Re: Draft of revision of CPSC Handbook for Public Playground Safety

Re; RESPONSE TO PUBLIC PLAYGROUND SAFETY DRAFT

RUNG LADDERS, STEP LADDERS & STAIRWAYS

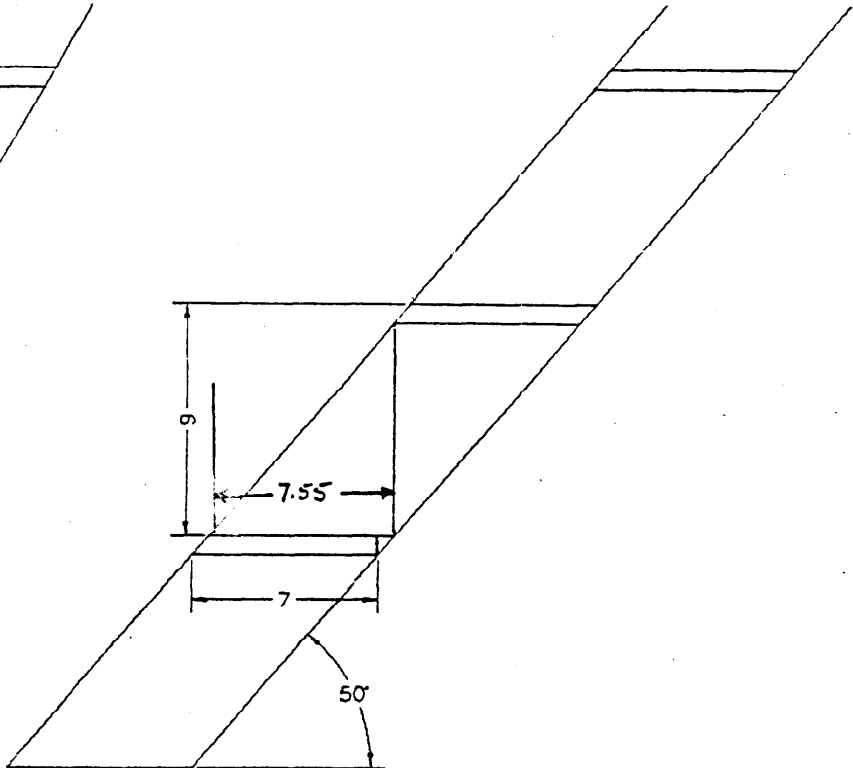
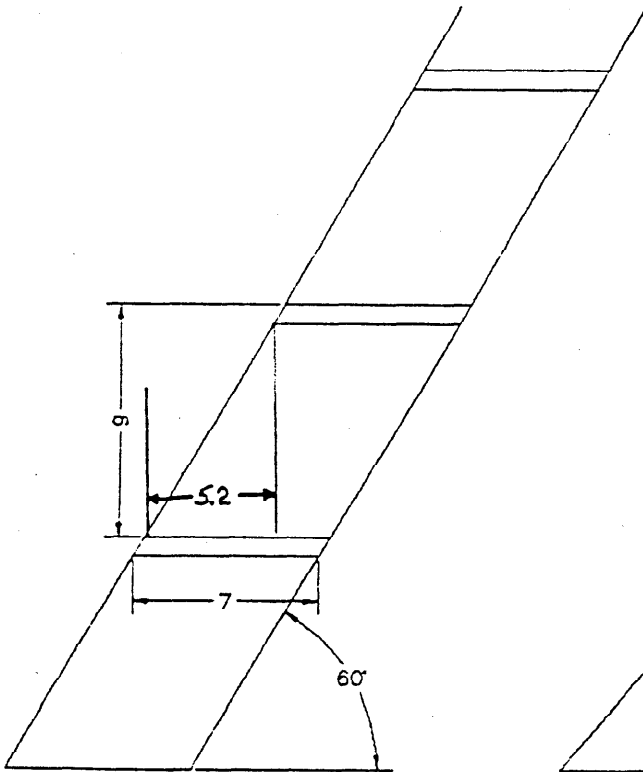
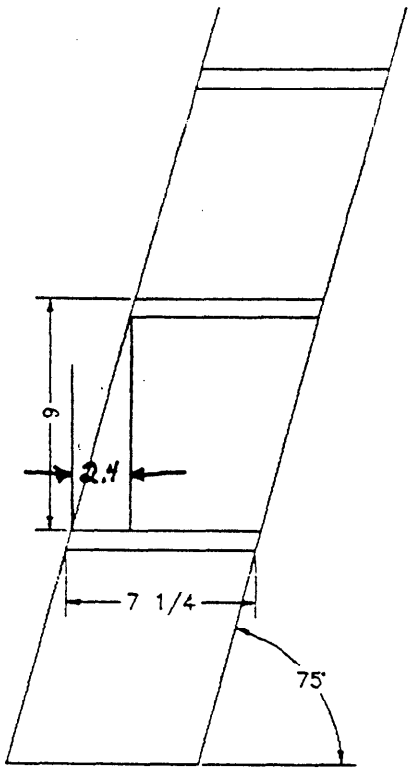
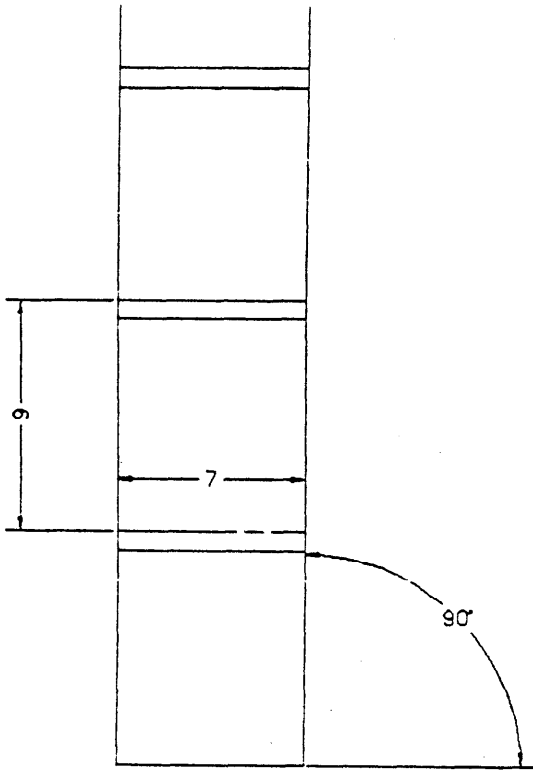
The fundamental difference between a stairway and a step ladder is not simply slope. The primary difference is in the way they are used. It is from this perspective that we must approach the specifications for step ladders. A stairway must be able to be ascended or descended safely while moving forward. For this reason the accessible tread depth must be at least as long as the heel to ball of foot dimension of the 95th percentile child of the oldest user within the age bracket. A step ladder is too steep to descend moving forward and therefore must be descended moving backwards (**If not, then where is the rationale for limiting stairways to ≤ 35 degrees?**). In this fashion the heel of the foot is not used and, in fact, the heel can become a hindrance in declining the ladder.

The theory of the ≥ 7 " tread depth for 2-5 year olds is that it will create a safer, more stable platform for ascending or descending the ladder. In reality 2-5 year olds will be encouraged to misuse the equipment. For example, a 52 degree slope on a step ladder with a 9" vertical rise between steps and a 7" tread depth would provide adequate footing for an average four year old (foot length is 5.2") to descend the step ladder while moving forward. In effect creating a non-compliant stairway (>35 degrees). Furthermore on ladders with a slope of >60 degrees (accessible tread depth <5.2 ") they will run the added risk of having inadequate foot support for descending and will most certainly fall if they try to descend moving forward..

Once the ladder approaches a slope of 70 degrees, the accessible tread depth is only 3.25" and it will force the child to descend backwards in the proper fashion.

- 1) Limit the tread depth to a maximum of 4". In order to avoid the entrapment problem and still allow for overhang of the foot on the step, the back of the step ladder can be enclosed.
- 2) Limit the minimum slope to ≥ 70 degrees.

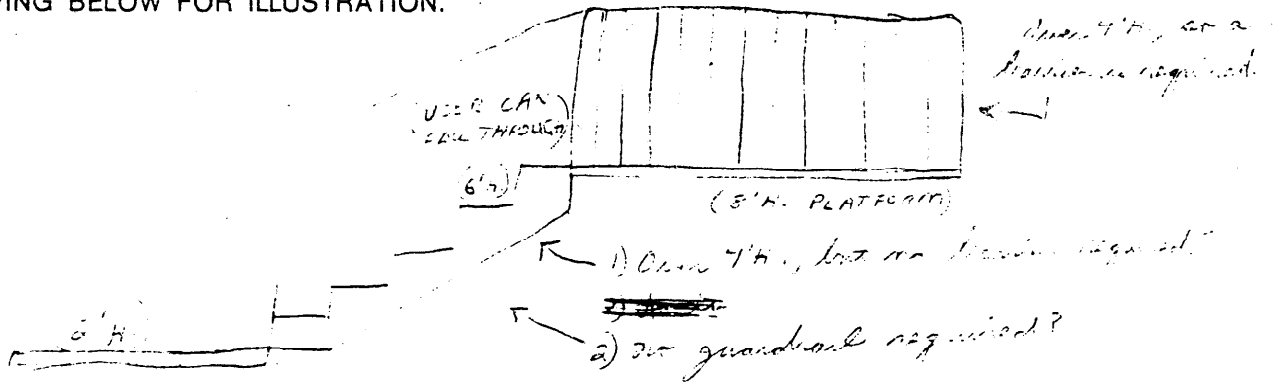
SECTION 10.3; Stairways & stepladders are "elevated surfaces". What about steps or stairs that are >20"H. for 2-5 Y.O.'s, or are >30"H. for 5-12 Y.O.'s, shouldn't the height of the handrail act as a guardrail and be designed to protect them from falling off as well as for handgripping? What about when steps or stairs are >30"H. for 2-5's, or are >48"H. for 5-12's, shouldn't the sides act as a protective barrier as well? Some mfgs. are doing this already, but again, we are not just addressing new equipment. SEE THE DRAWING BELOW FOR ILLUSTRATION.

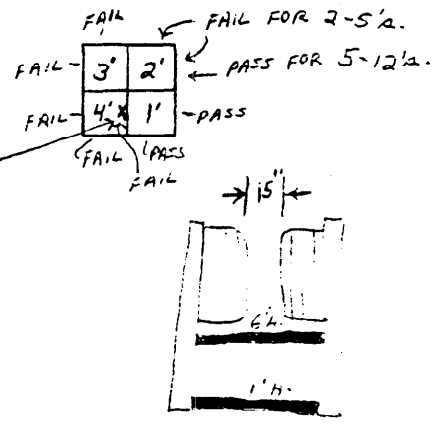
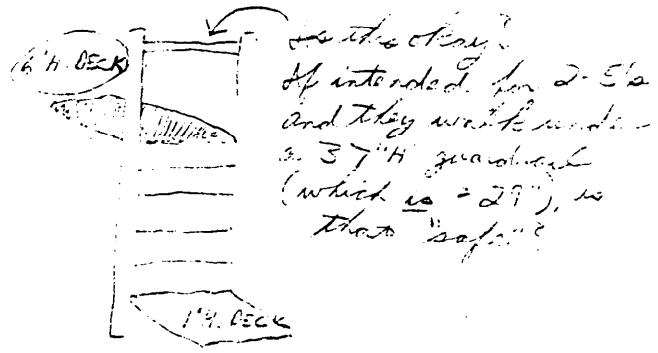
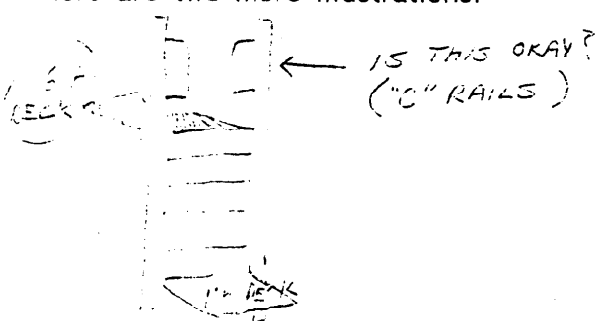
B) (Last ¶); John, we discussed this at the June ASTM meeting. The statement of "so that fall height does not exceed 20" (for 2-5's) and 30" (for 5-12's)" indicates that we do not want children falling from distances greater than those. I know it also happens to be the heights when a guardrail is required, however, I am concentrating on the child inadvertently falling off the side of a platform. My contention is that there was great concern for falling >18", or >20", or >30", or >48", etc., and here we have much more than that. We must make it clear that adjacent (or layered, or stepped) platforms must have a limit due to potential falls. Steve King, Fred Druck, etc., agreed that they had set limits on theirs, but they were different. Fred's is 36" max., and I believe Steve said his were either 32" or 48" max.. **FALLING HAS BEEN IDENTIFIED BY CPSC AS THE MAJOR CAUSE OF INJURIES!**

Please refer to the xeroxed pictures and their notes. Please refer to the plan view (aerial) to the right. This shows adjacent platforms with no guardrails, barriers, or vertical ladders at all for clarification purposes. Focus on the 4' and 1' platforms, where it fails. Now look at the ~~one~~ ^{DRAWING} below it. It shows the new 15" opening and what a "proper" guardrail or barrier is about to become. I have not included a vertical ladder to make a point. They can fall from 6' to 1' here, whether they have a ladder there or not. Certainly we do not want to say it's not okay to fall from a 4' deck to a hard surface but it is okay to fall from a 4' deck to a platform (hard surface). My own experience was an approximately ground level platform with a vertical ladder going up to a 7'6"H. platform which kids fell off of and onto the lower platform. See the enclosed picture. I am including yet another picture of a unit with a 6' difference in platform heights that the owner removed.

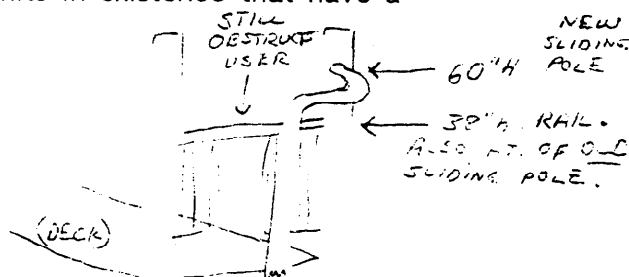
B) Add "There shall be an unobstructed open space of no more than 15" horizontal and at least 60" vertically." RATIONALE; there are many units in existence that have a 1" o.d. horizontal pipe "guardrail" at the 38" height.

The reason for raising the pole to 60" was so they would not stoop, or duck down, to access it. If you install a barrier with a 15" wide opening, there is no vertical minimum stated. If we make them replace a 38"H. pole with a 60"H. one, they would still have to duck anyway if there were a 38"H. rail there. See drawing at the right.

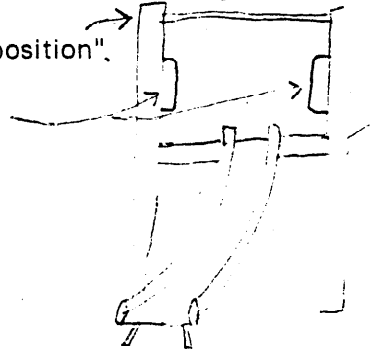
B) (Page 31, 3rd ¶ -or- fourth line); ASTM has not been able to define a "gap", as far as I know. This seriously needs to be done for your revision, so please examine this.

A hairline thick gap fails according to one top consultant, which is not justifiable. On the other hand, is a 2" gap okay? I would think so. What about a gap between the panel and a support? Maybe not. SEE THE ENCLOSED PHOTOS

Add to the end of this sentence ".... slide chute, including any panel, hood, etc."

Also, add "A gap is defined as an opening $>.04$ inches and ≤ 2 inches". RATIONALE; the .04" is from the entanglement size already established for slides in Section 9.4. The 2" is a size I thought would be appropriate to allow a glove to pass through, yet still not entangle (see picture enclosed). This establishes a measurable range that can be allowed into designs, and courtrooms, without question. This area is too critical to leave it ambiguous.

SECTION 12.1.2 (p. 2 of 2)

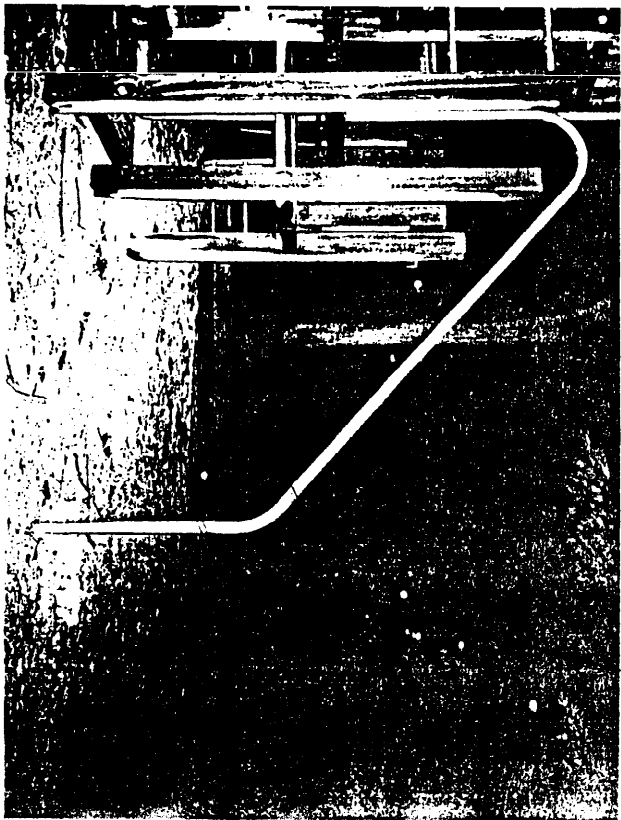
SECTION 12.1.2; regarding the second ¶ that is stricken. In a discussion with CPSC at the June ASTM meeting, I learned that this section was proposed to be taken out because of it's confusion in wording as well as the possibility of the elimination of arch climbers if it was applied to those. Another example given for it's deletion was that the "Jungle" or "Tower" climbers were no longer being produced. However, this does not matter since there are a lot of them still out there. Remember, we are not writing a guideline only for current and future equipment being manufactured, but for equipment that may still have decades of service left in it. So, we have to include those as well. Plus, mfgs. are making other types of equipment now that have the same, if not worse, hazard. The "restriction in design" argument cannot be employed in all cases, especially this one. We do have data and injuries occurring because of these designs. If someone says to prove it, you should say that they should prove otherwise!

Please examine the xeroxed pictures on the two enclosed pages. One shows a hazardous "½-loop arch climber" as seen from the platform. If the user fell down to the rungs below it would possibly be fatal. Next to it on that page is the infamous Jungle or Tower climber that the sentence was apparently written for. On the next page you'll see a (highlight) version of a climber that originally had a concave center where kids would fall onto. There are still a lot of those out there, but this one was converted so that the center was replaced by tires so they could fall onto something more forgiving than the hard pipe that were 5 feet down. Again, those with the center pipes are still out there, and thousands of climbers that are designed with the same hazard are out there.

Leave the deleted statement in, but give examples that exclude arch climbers as the line we draw for the level of risk we accept. Either that or come up with an angle or curve maximum that you measure the 18" with, in order to exempt arch climbers.
